Route Section 9
(Alignment Sections 19, 20, 21, 22, 23 and 24)

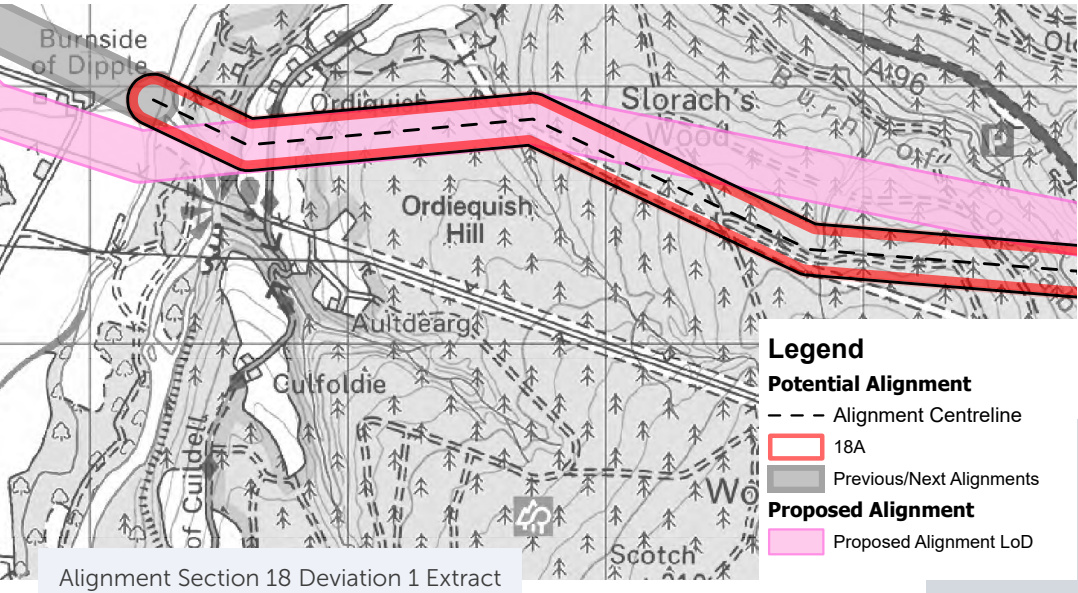
In Section 18 we identified two alignment deviations (Alignment 18J1 and 18J2) which would provide a connection from the revised Proposed Alignment in Section 17 (Alignment 17D) to the Potential Alignment 18A in this section. Further assessment of these options concluded that Alignment 18J1 was marginally preferred over Alignment 18J2, as it is slightly better for landscape character and visual impacts which

is a key driver in this sensitive landscape area. Alignment 18J1 is also preferred from an engineering perspective as it crosses the River Spey at a less steep point than Alignment 18J2. Further information is provided in the Alignment Deviations Appraisal in Appendix C. Alignment 18J1 will therefore be taken forward as the Proposed Alignment for EIA and detailed design.

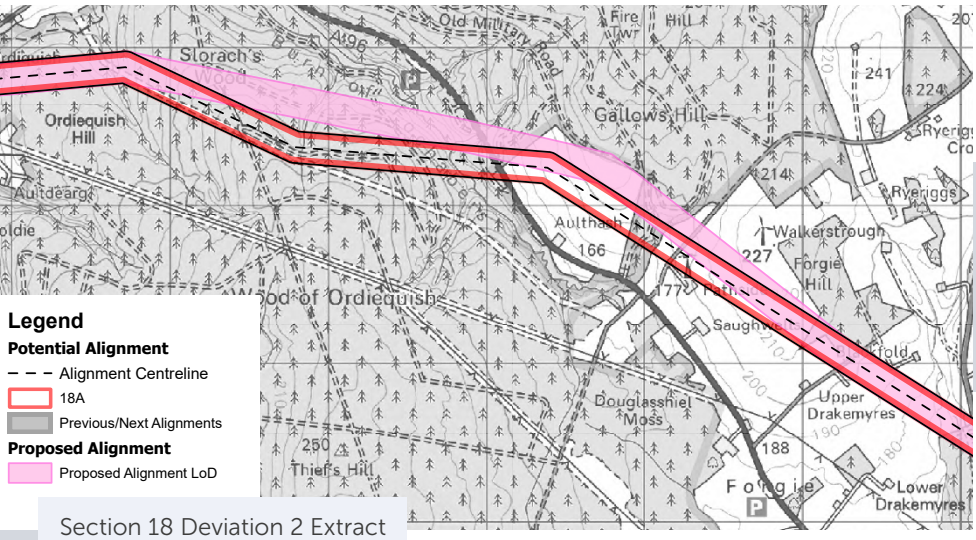
Also within Section 18, following review of consultation feedback we identified another alignment deviation (Alignment 18H) which takes a more northerly alignment to Potential Alignment 18A through Slorach's Wood and to the east of the A96, to reduce impacts to forestry operations and avoid a private water supply. Further assessment concluded

that Alignment 18H is acceptable from an environmental, engineering and cost perspective in comparison to the Potential Alignment 18A. Further information is provided in the Alignment Deviations Appraisal in Appendix C. Alignment 18H will therefore be taken forward as the Proposed Alignment for EIA and detailed design.
